ADDENDUM NO. 2

MAKUU OFFSITE WATER SYSTEM PHASE 2 PRODUCTION WELL, RESERVOIR AND SUPPORTING FACILITIES

HALONA, PUNA, ISLAND OF HAWAII, HAWAII

IFB NO.: IFB-13-HHL-002

S-4

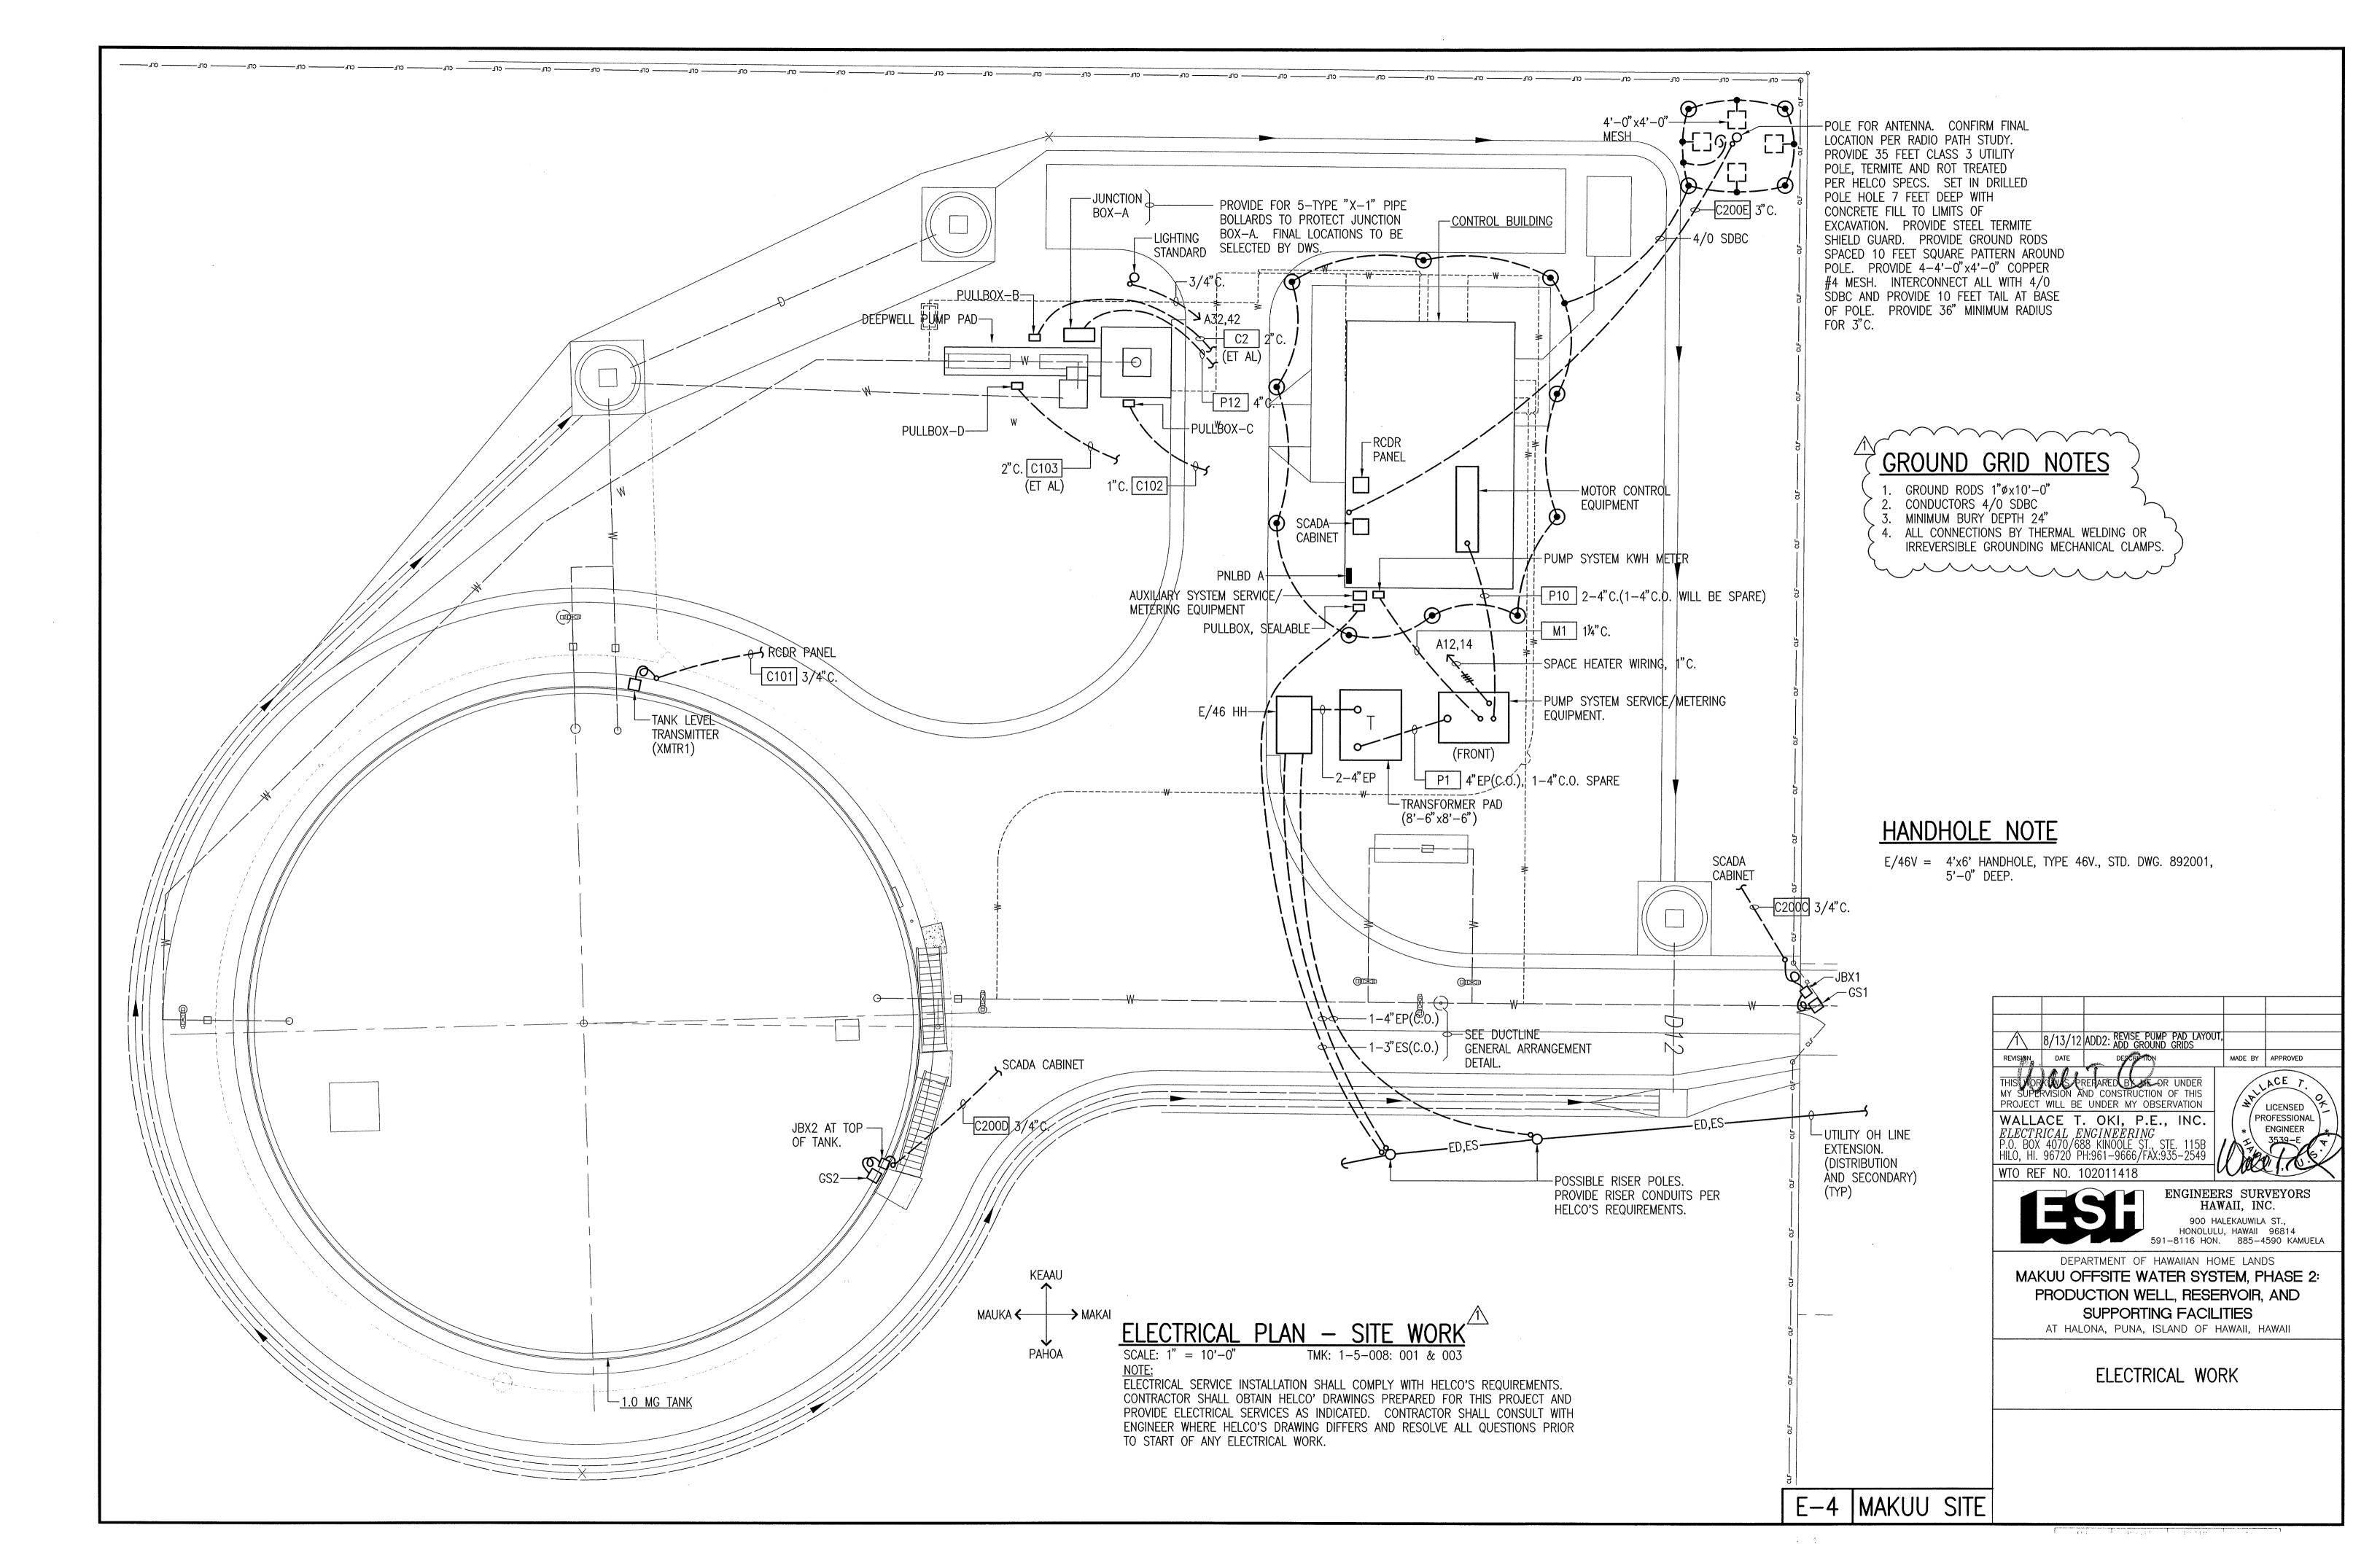
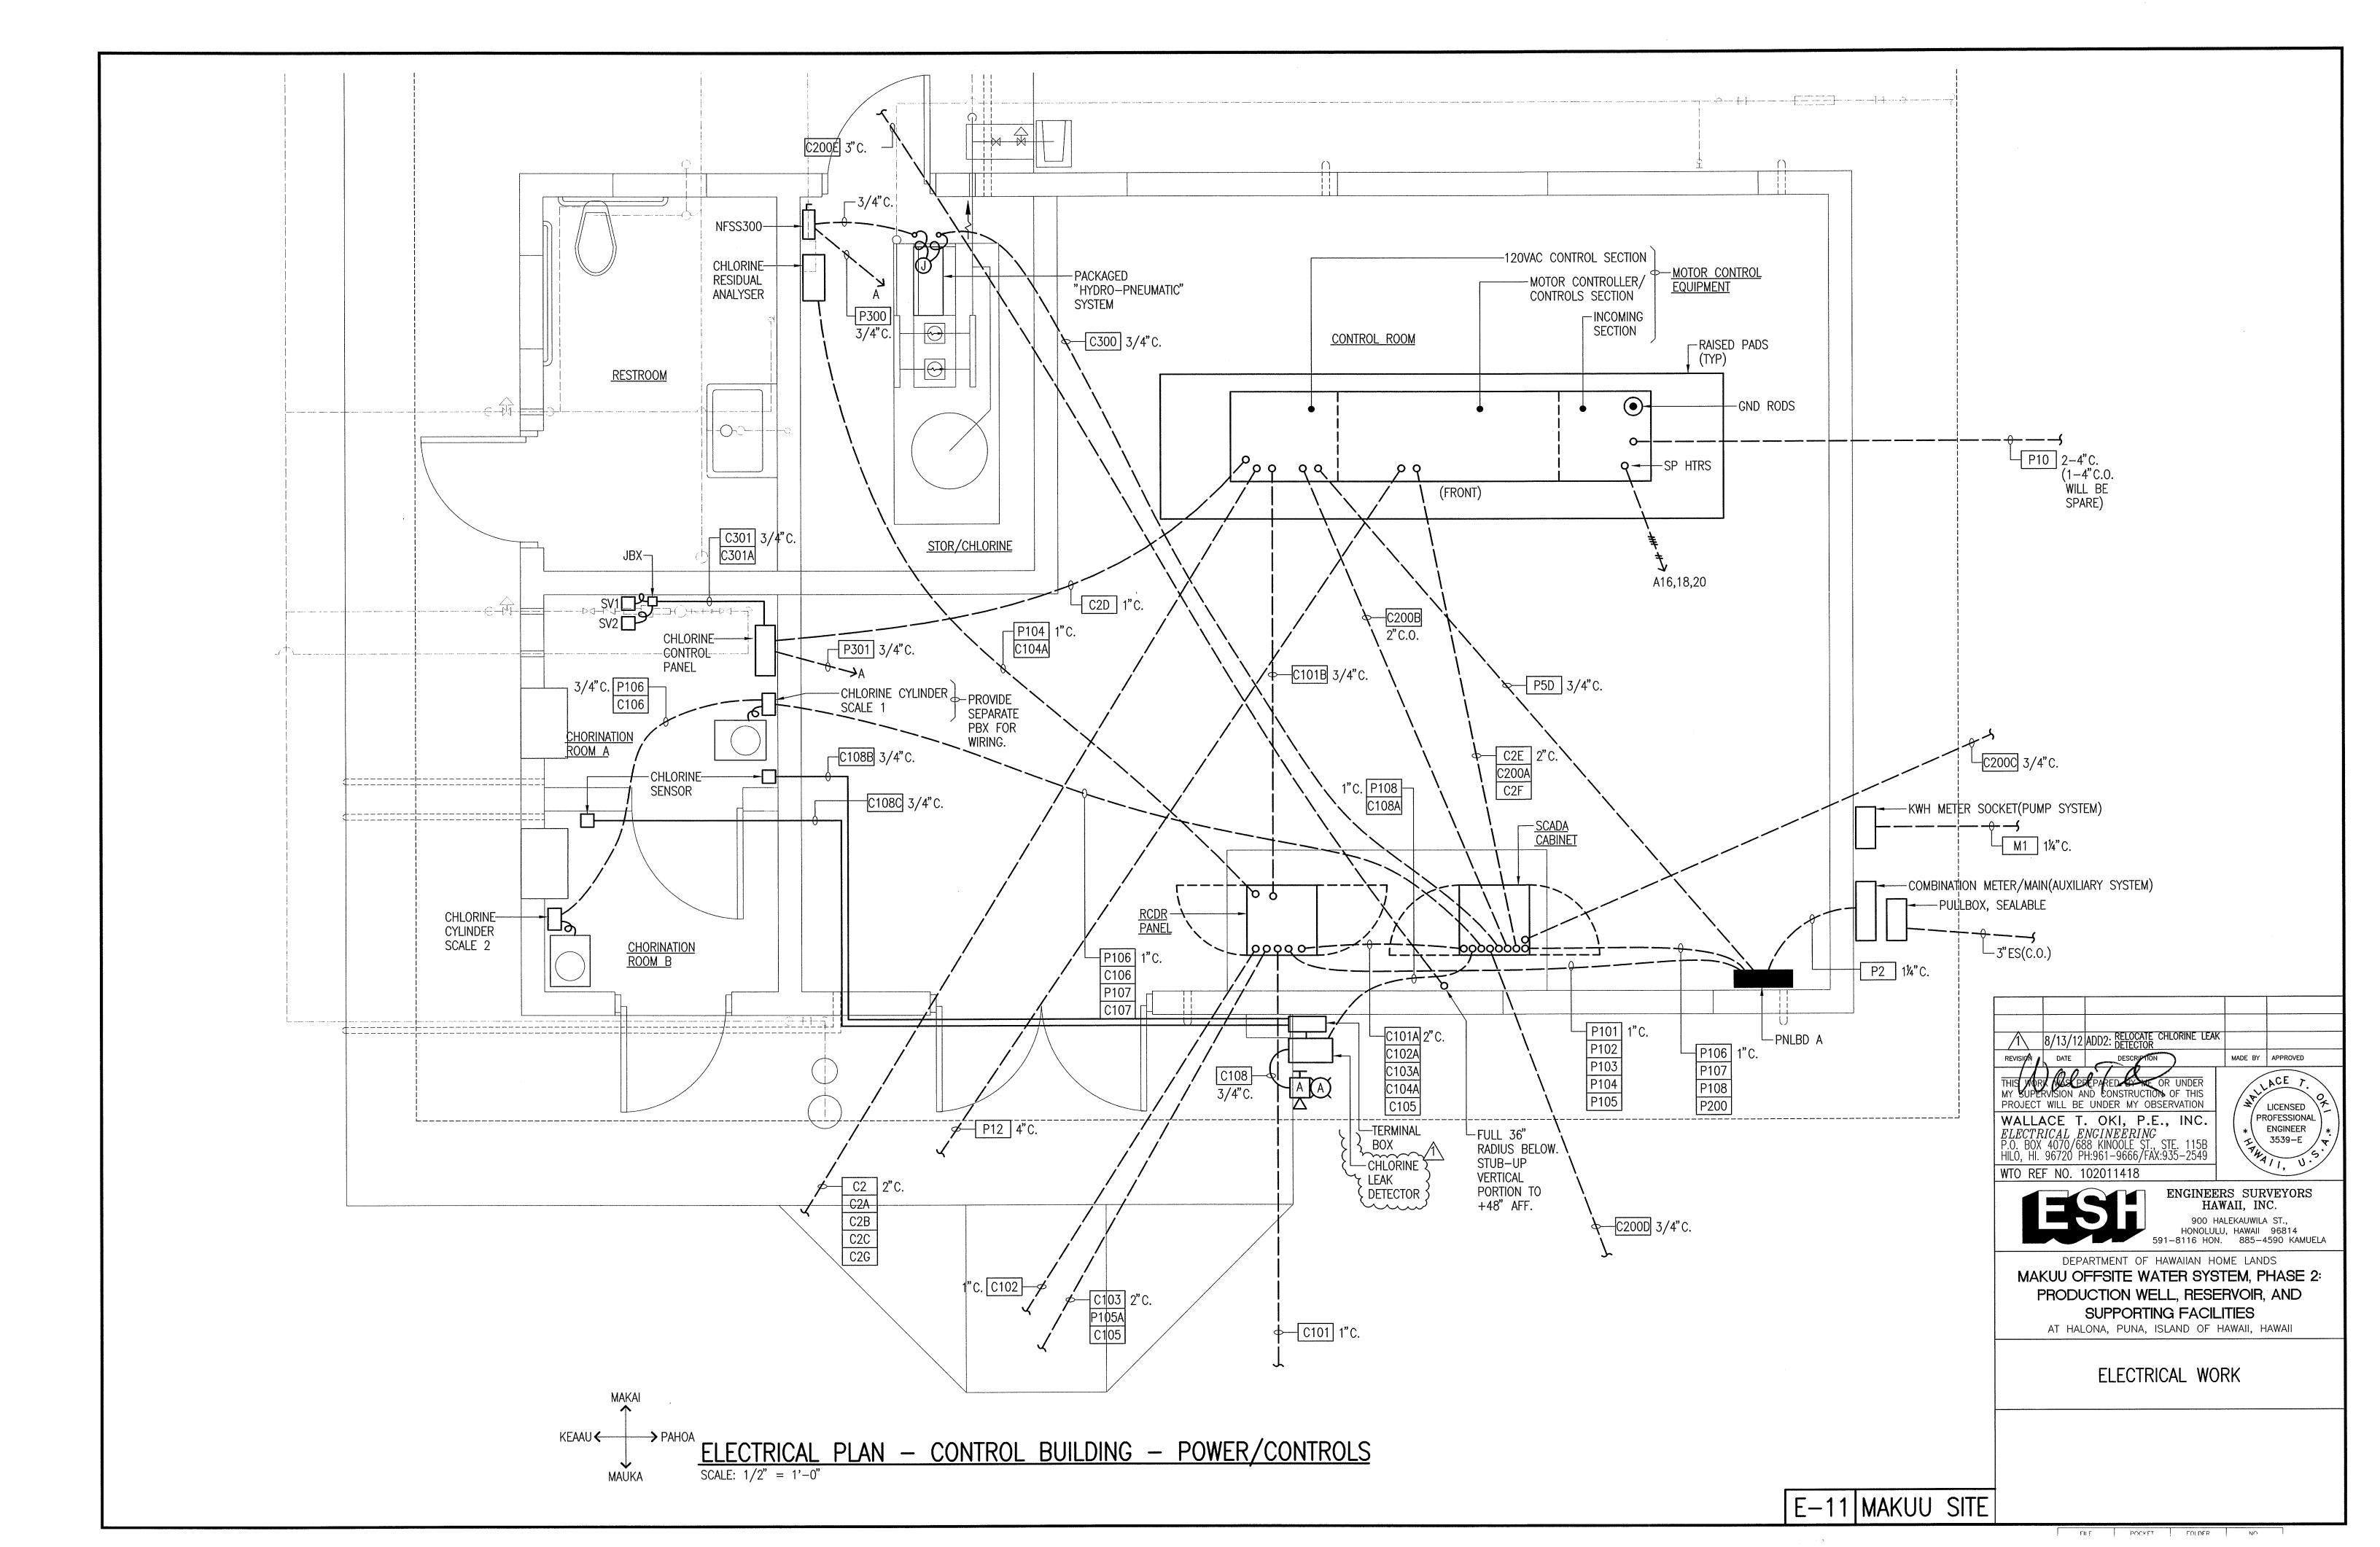
Section 303.07.F.2.n states the Importance Factor shall be 1.5 while Sheet S-4 of the drawings states the Importance Factor is 1.25. ACI 350 and AWWA D110 use 1.25 for essential facilities while IBC 2006 uses 1.5 for essential facilities. It is our understanding that Hawaii has recently adopted IBC 2006. Please have the Engineer review and determine if the project should also include IBC 2006 as part of Section 303.07.F.1 and the General Notes on Sheet S-4 of the plans and if the Importance Factor for the project should include both 1.25 and 1.5.
